ADDENDUM # 1

RFQ 7575502

**TITLE: Interior Renovations RIAG Building 150 South Main Street,
Providence**

This Addendum forms a part of the Contract Documents and modifies the Drawings and Project Manual as hereinafter indicated.

E101

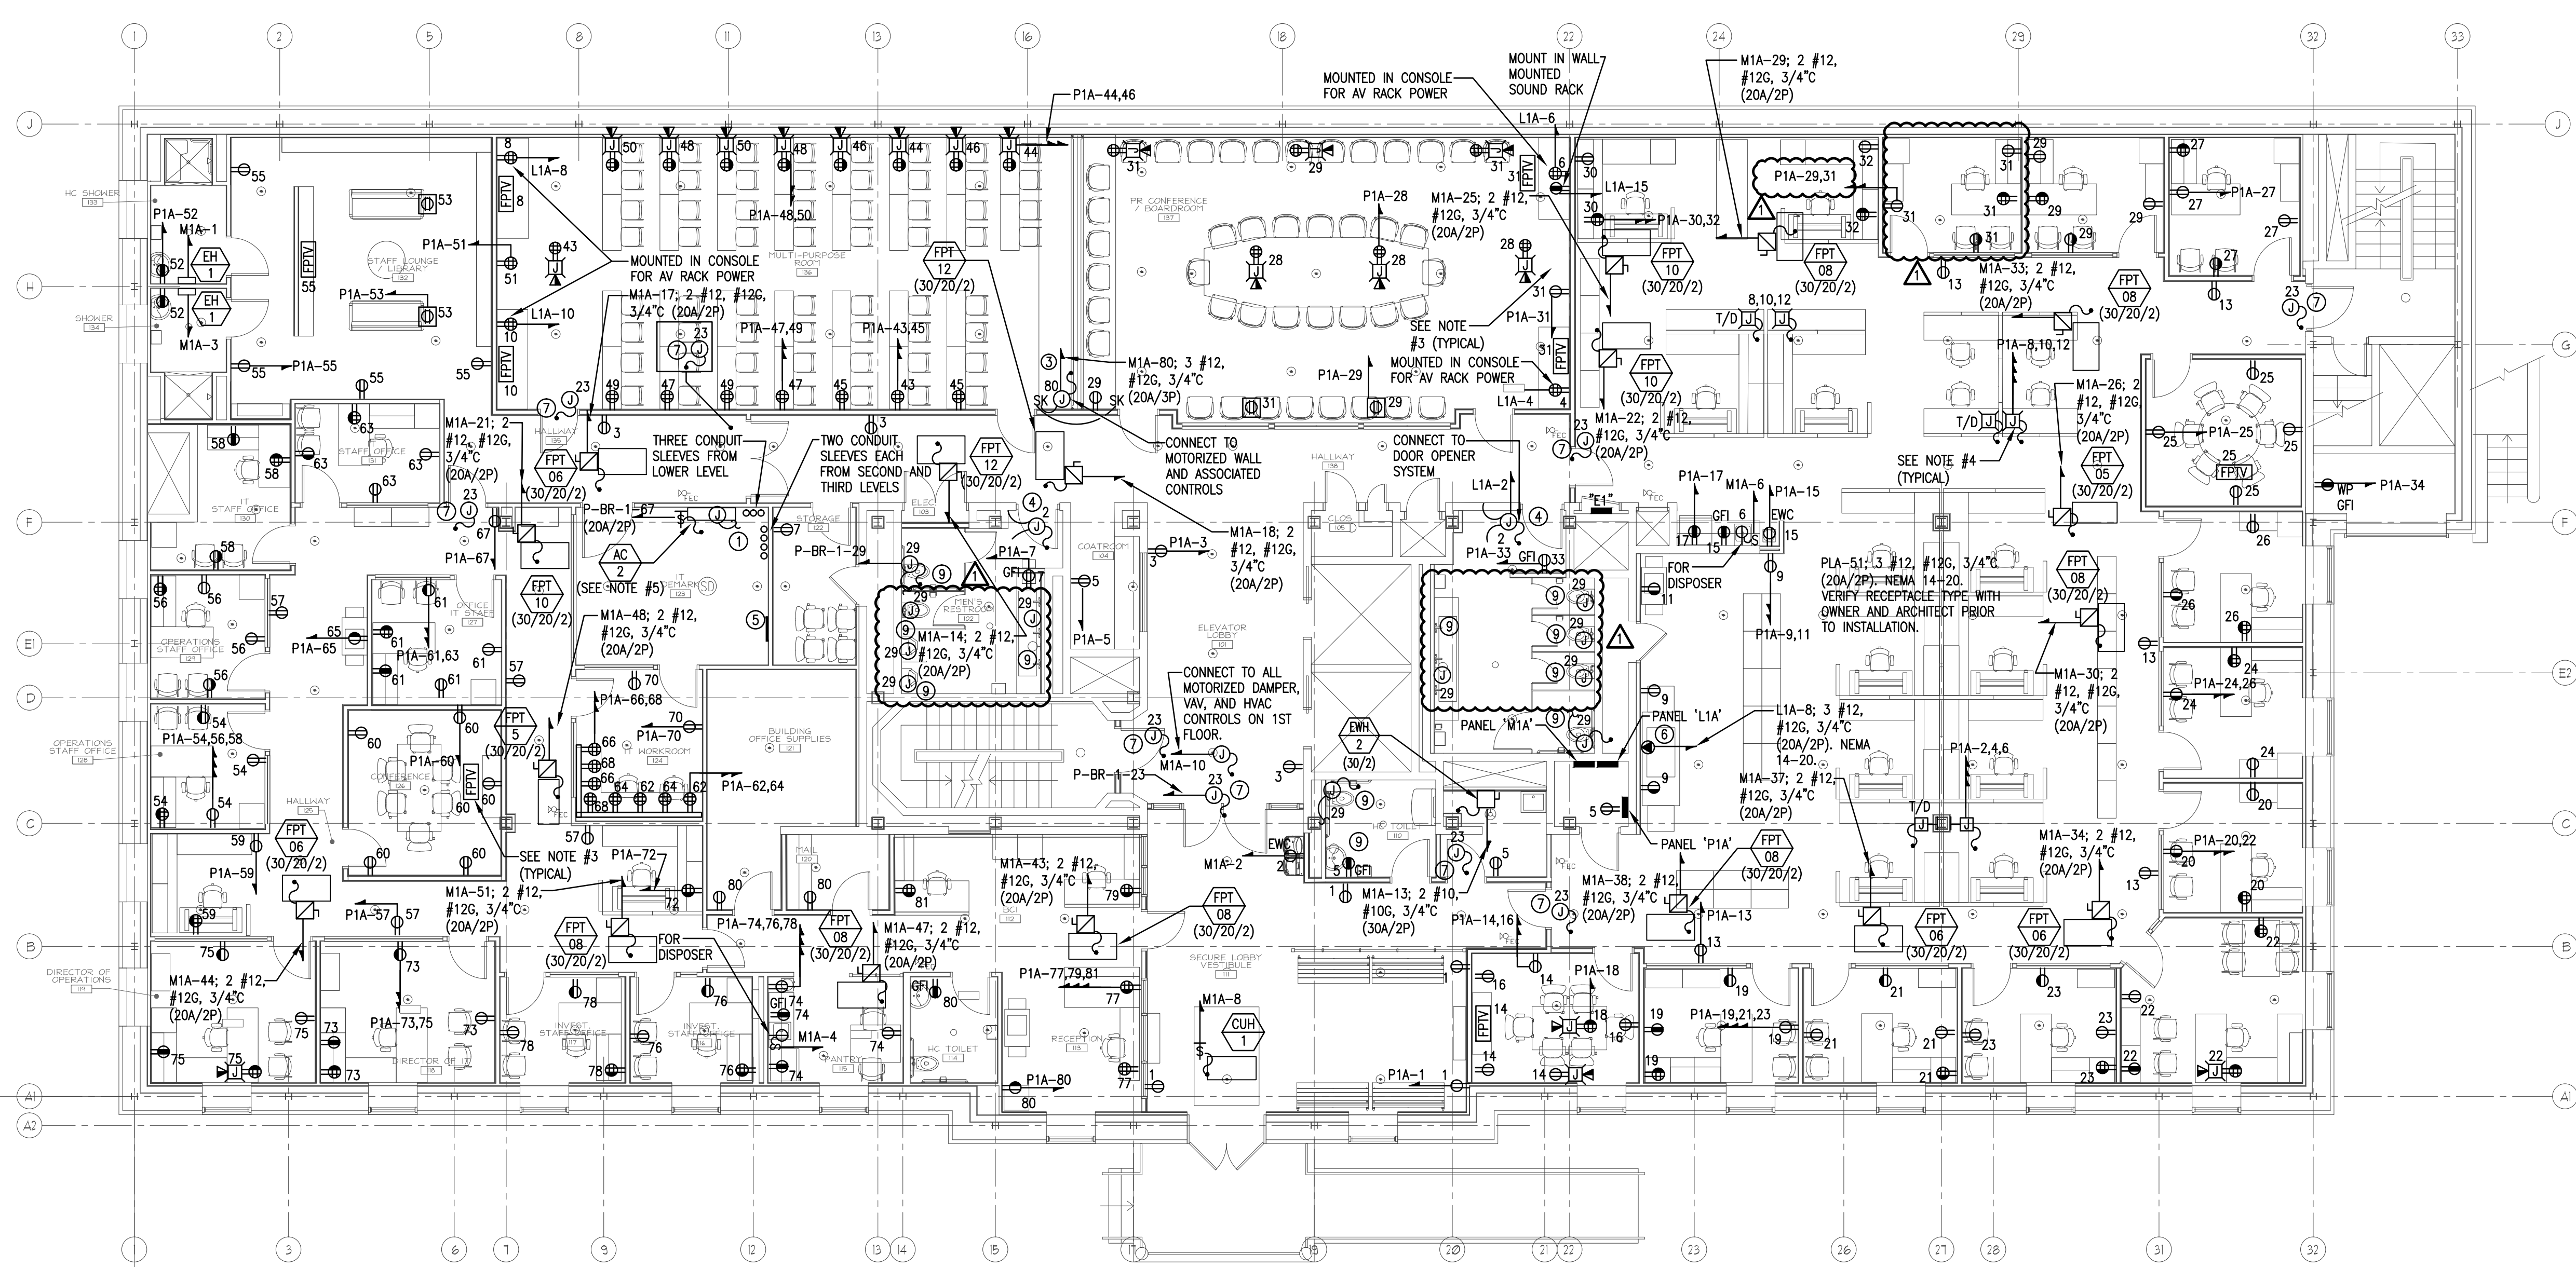
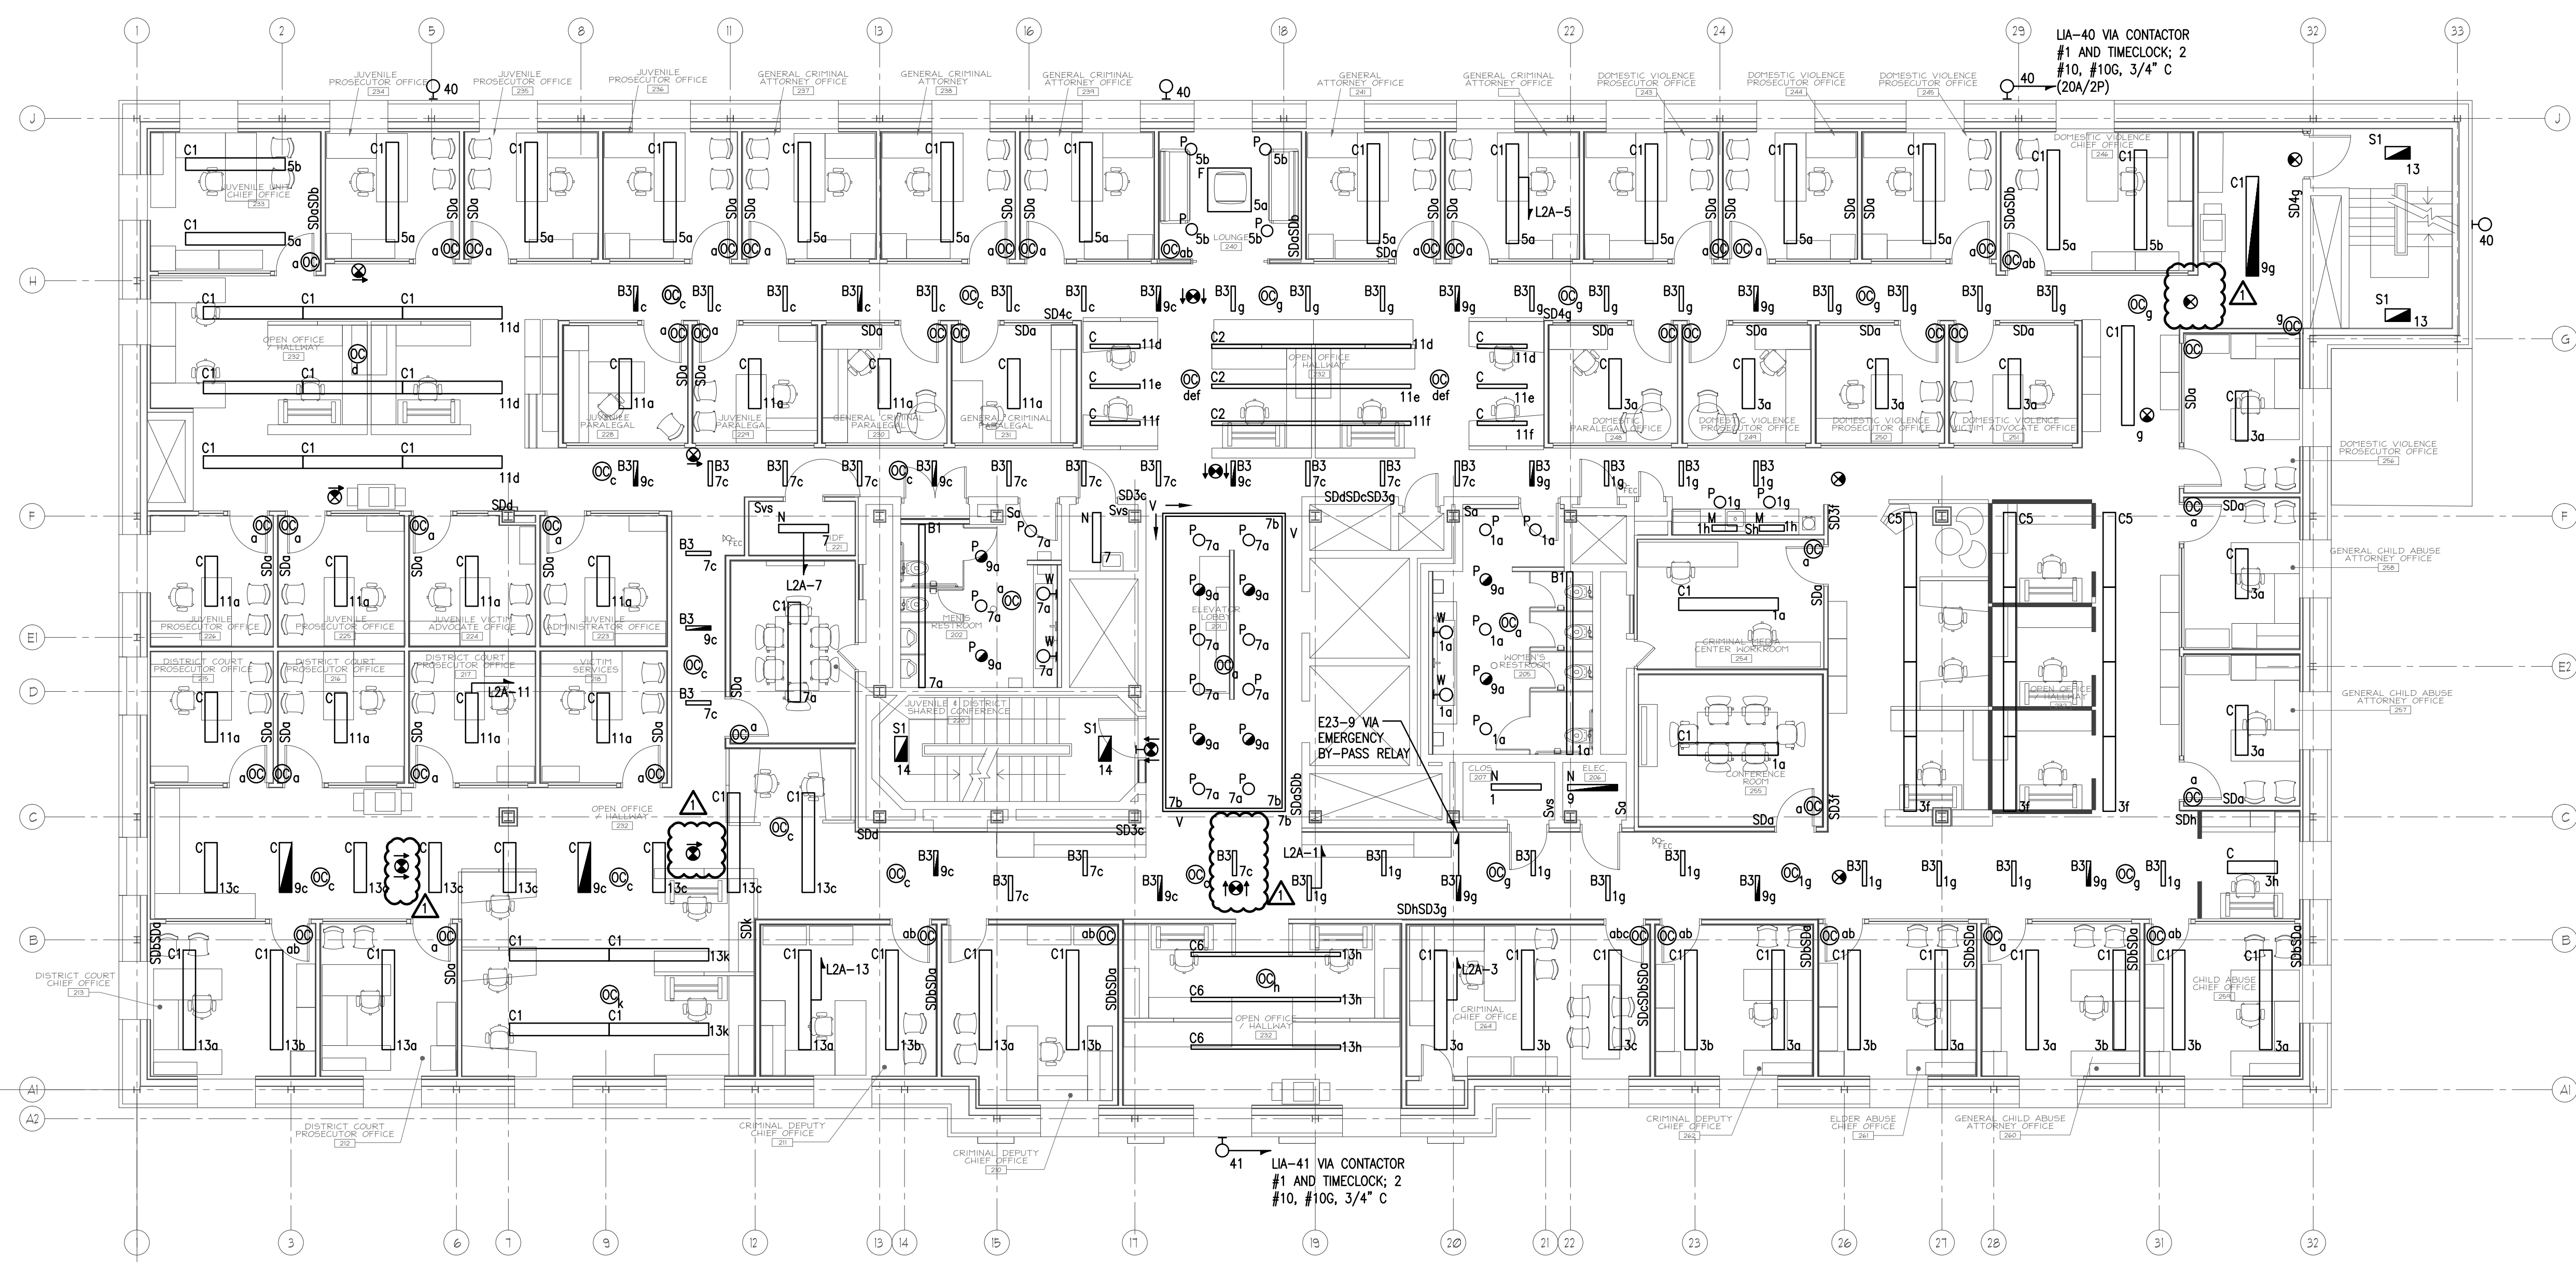
- B. Electric service entrance revision.
 - C. Add exit lighting.
 - D. Clarify toilet room flush valve power.
6. Drawing #E101:
 - A. Add exit lighting.
 - B. Clarify toilet room flush valve power.

- C. Clarify office receptacle circuiting.
7. Drawing #E102:
 - A. Add exit lighting.
 - B. Clarify toilet room flush valve power.
8. Drawing #E103:
 - A. Add exit lighting.
